Work Order Title: Polk Administration Building Fire & Life Safety Upgrades Supplemental III

SUBJECT: Fire & Life Safety Upgrades Project/ Polk Administration Building  
Supplemental Work Order Number – 023228.03

**023228.03- 1900 Polk SWO #3- Scope of Work**

## Request For Information

ASK RFI-05A  
DATE: 12.22.2015

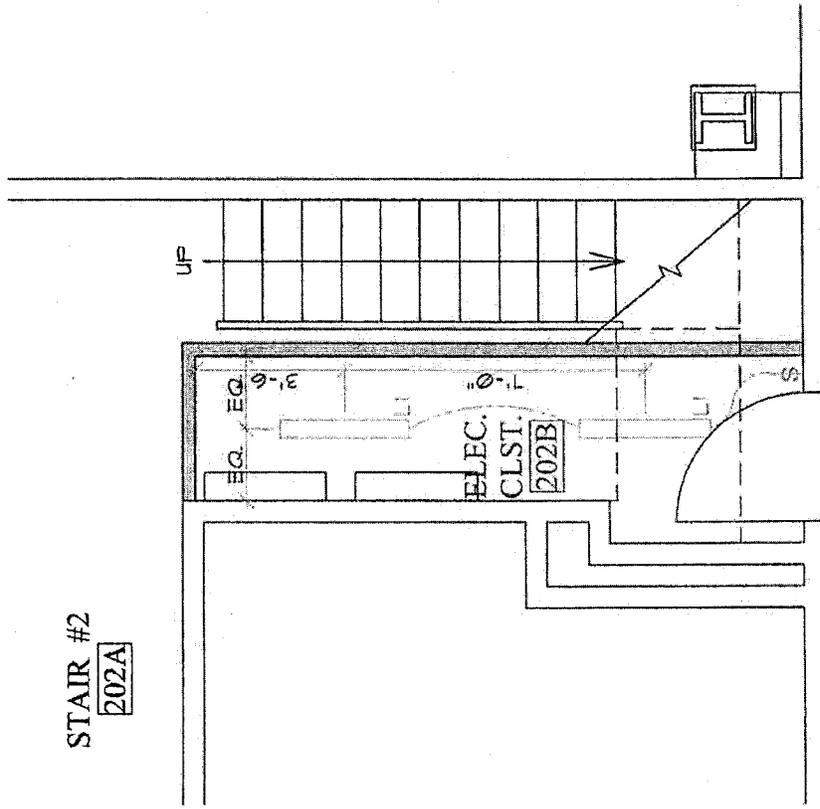
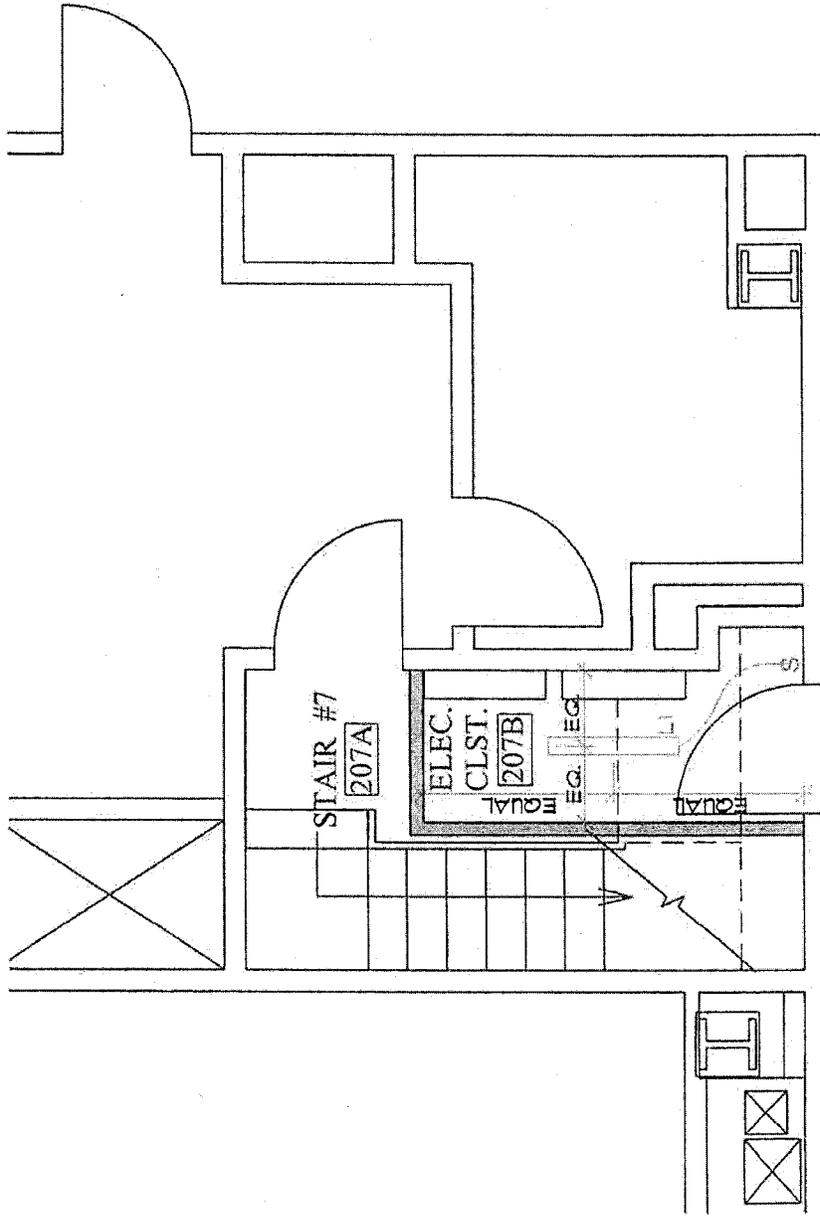
**Re: 2nd Flr. New Electrical Rooms Lighting**

We built out the new electrical rooms 202B & 207B as detailed on the plans. We can't find any reference to providing new lighting for these rooms.

**PROVIDE PHILIPS LIGHTOLIER T225-UNV-EB SUSPENSION HUNG FLUORESCENTS (L1) OR APPROVED EQUAL WITH SWITCH AS SHOWN ON ATTACHMENTS. SEE ASK RFI-5A, ASK RFI-5B AND ASK RFI-05C FOR LOCATIONS AND DETAILS.**
